STORM SEWER PLAN & PROFILE
LINES C & D
TIMBER CREEK ESTATES
CITY OF ROCKWALL, ROCKWALL COUNTY, TEXAS

REVISION	DATE
WLD.	
CHECKED	
K.E.B.	
DRAWN	
2/01/01	
DATE	
9913 STM3	
PROJECT

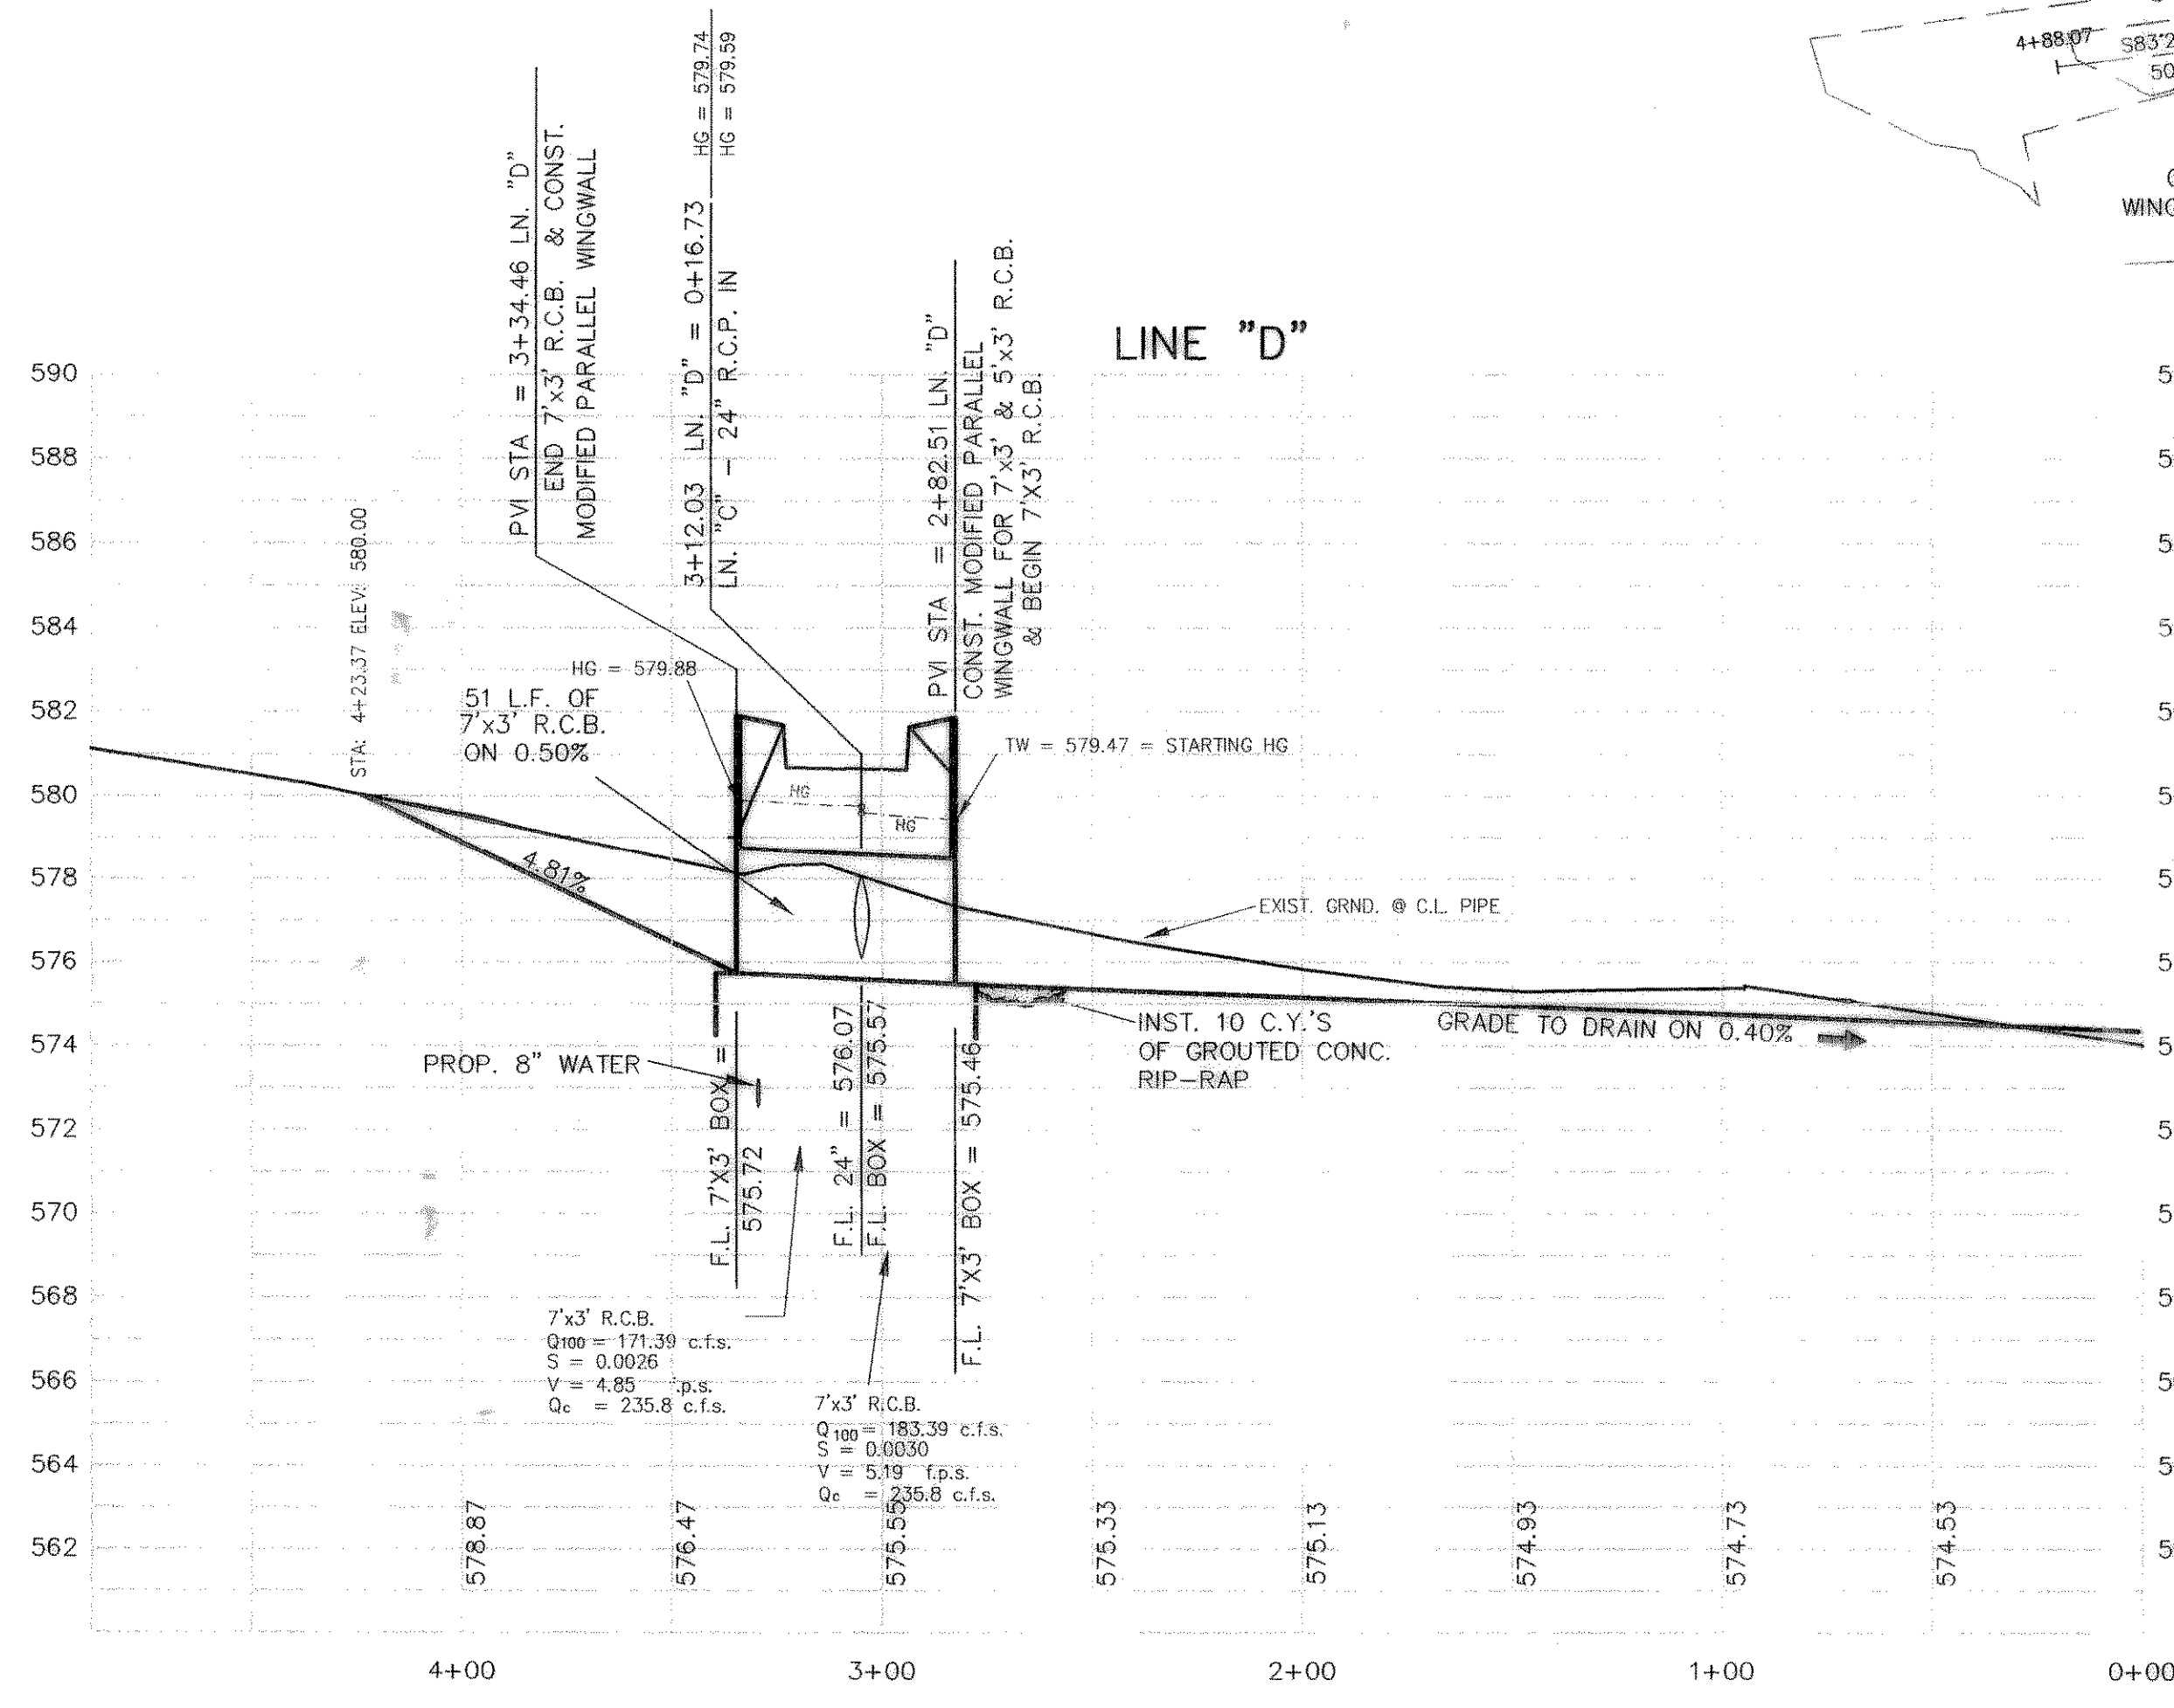
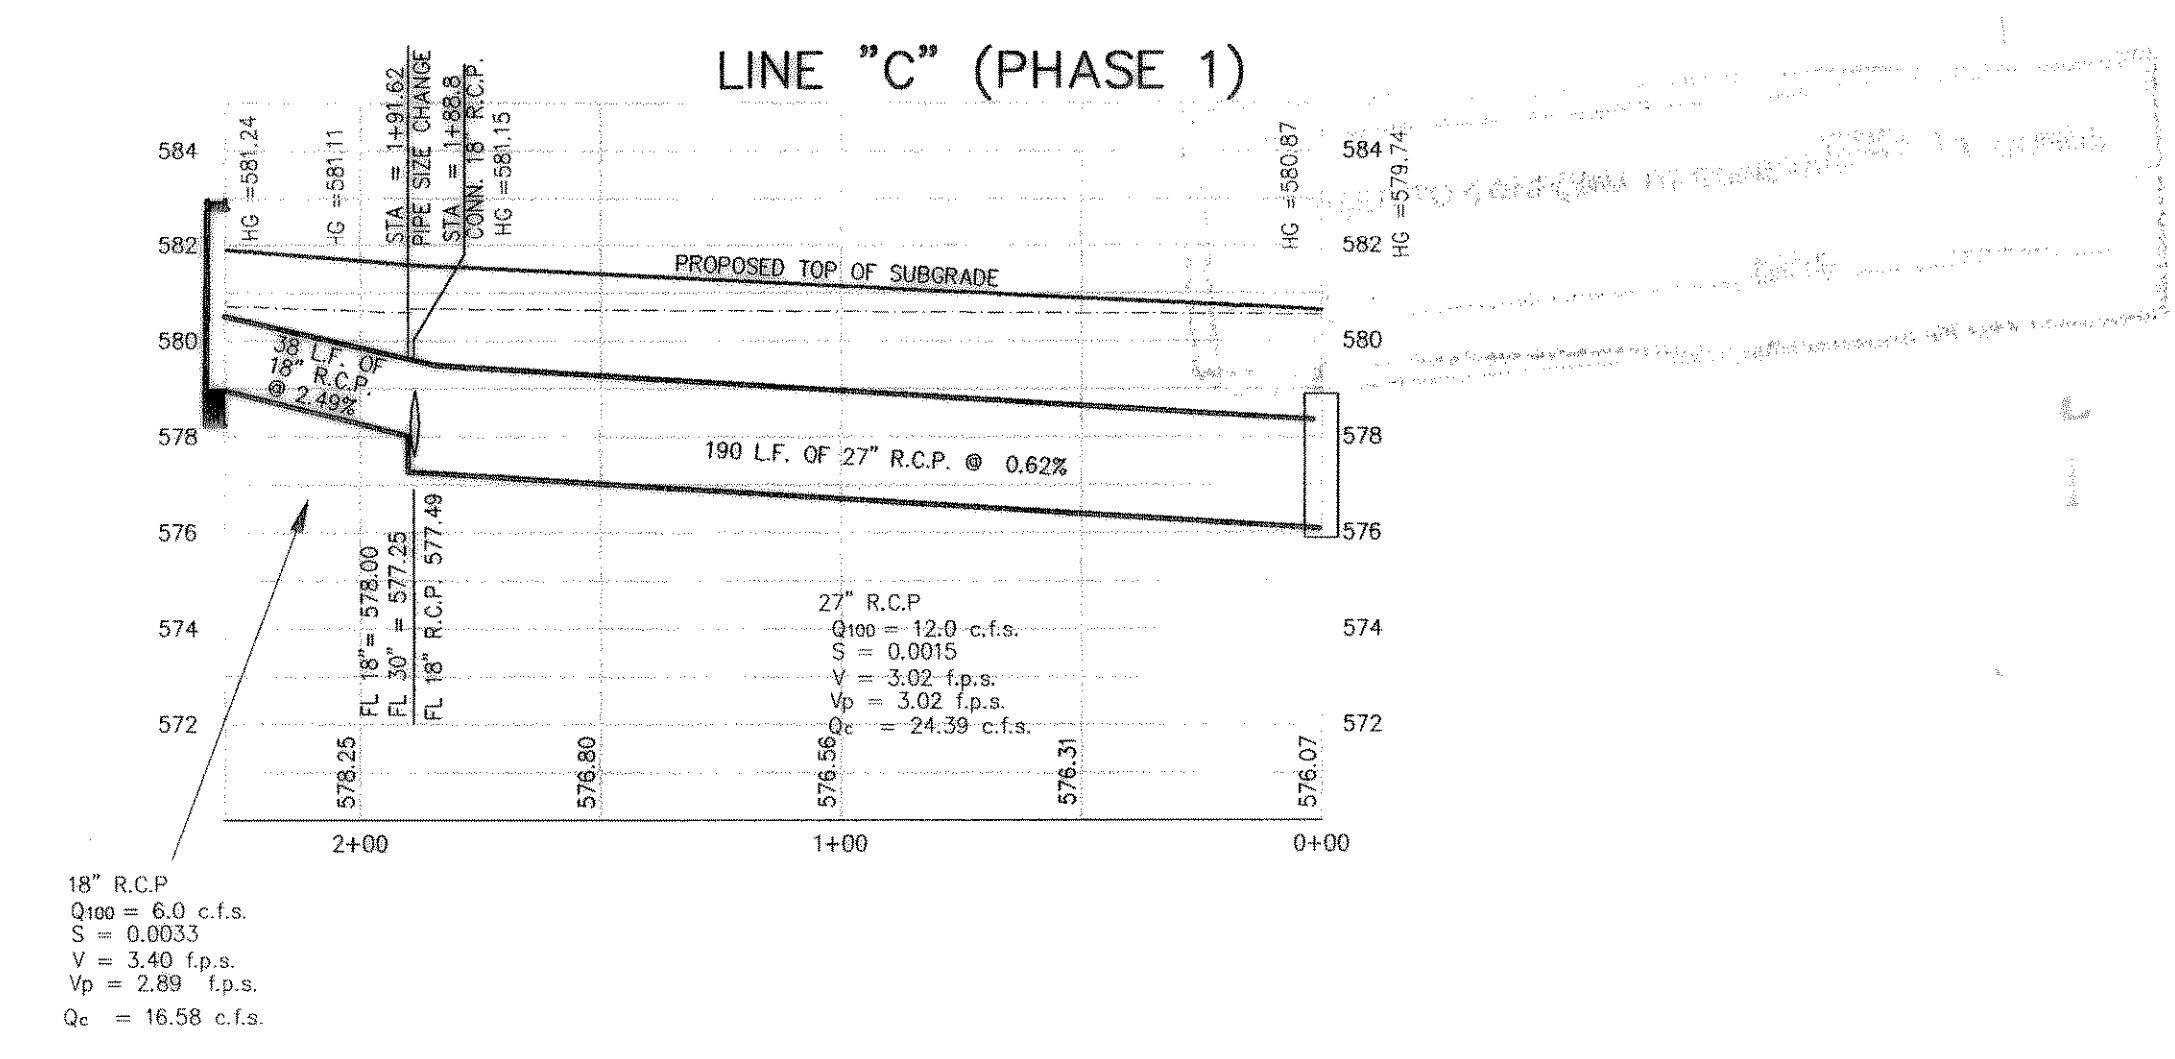
REVISED TO CONFORM TO CONSTRUCTION RECORDS.
DATE: 5/2/00

REV. 9-27-02
CHG. 5-36" TO 7'x3' RCB
